RE: H. B. ROBINSON UNIT NO. 2  
DOCKET NO. 50-261  
FACILITY OPERATING LICENSE NO. DPR-23

ENCLOSURE A

H. B. ROBINSON UNIT 2  
CYCLE 4 RELOAD APPLICATION

Response to NRC Staff  
Request for Additional Information

Figure 1: SCHEMATIC OF ONSET OF STABLE AND UNSTABLE FLOW CONDITIONS

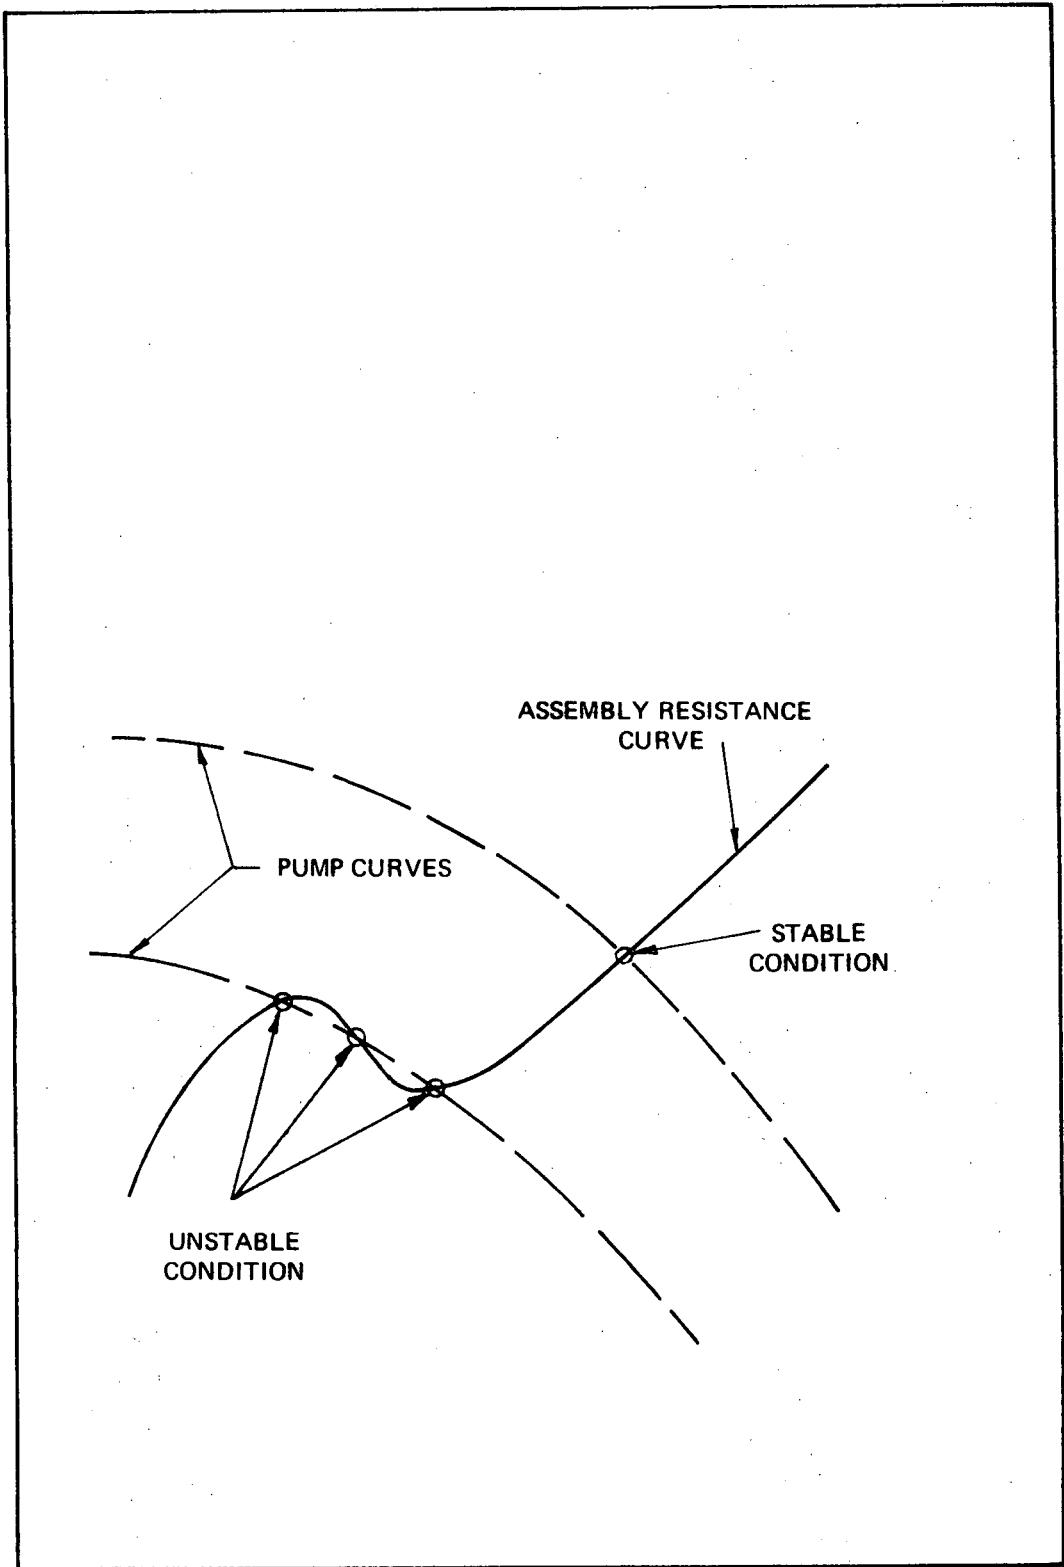
Provide a discussion of hydraulic core flow instability effects, which considers the flow resistance differences existing between ENC and Westinghouse fuel.

In order to assure stable thermal hydraulic operation of the H. B. Robinson reactor, a stability analysis was performed to determine the onset of flow instability and to show the margin between operating conditions and the onset of flow stability. A flow instability requires that the pump supply or demand curve cross the system resistance curve at more than one point. Figure 1 illustrates both the stable and unstable operating conditions. Since the pump curve in the reactor has a negative slope, the maintenance of a positive slope ( $dP/dG > 0$ ) on the resistance curve over the operating range is sufficient to prevent a flow instability.
